10/517,839

**Advisory Action
Before the Filing of an Appeal Brief**

DETAILED ACTION

1 of 6

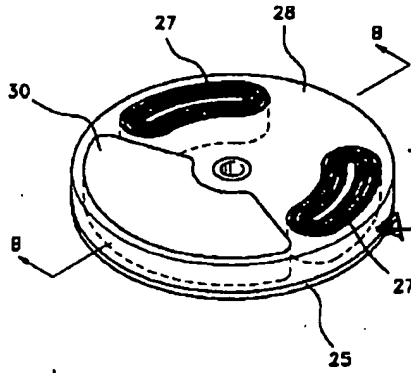
the coil being covered by
the rotator's base (9)

Thus, the rotator does

covers the outer circumference
of the coil

2 of 6

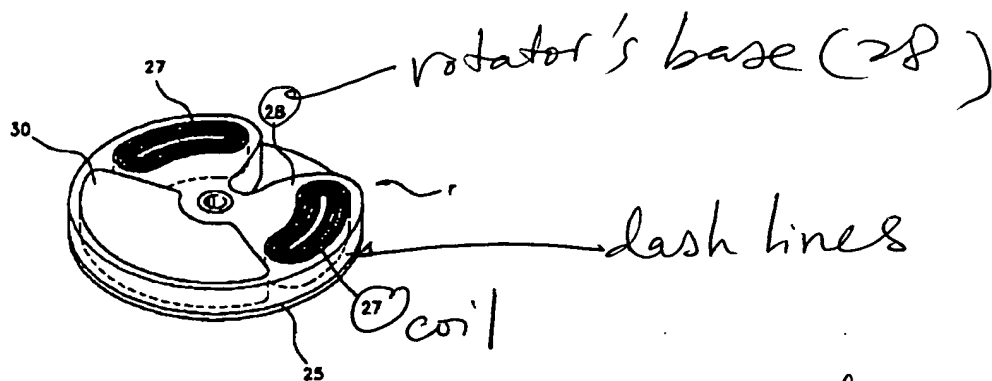
Thus, rotator does covers
the outer circumference of
the coil

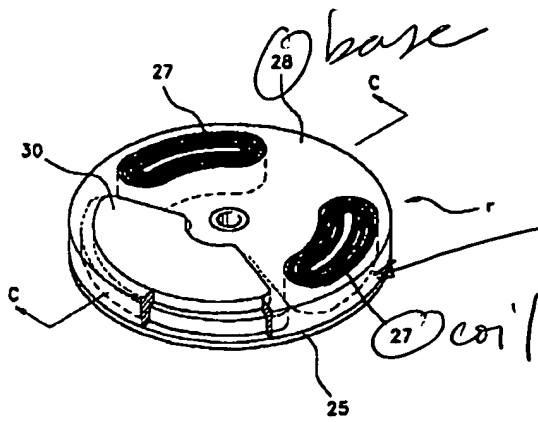
Again

dash lines illustrate
rotator covers
outer circumference
portion of the coil

4 of 6

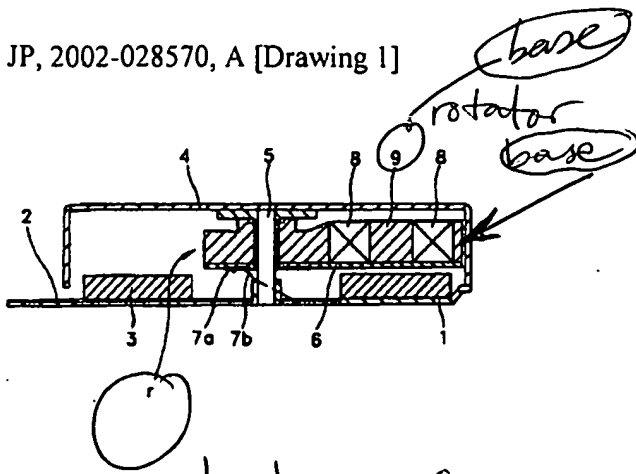
Rotator (r) with resin base (9)
 extended around coil (8);
 therefore, covers the outer
Circumference of the coil

5 of 6

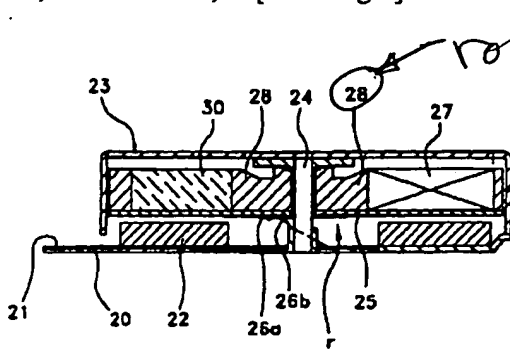
rotator's base surrounds the
(28) coil (27)

again showing

rotator covers circumference
outside of the coil —
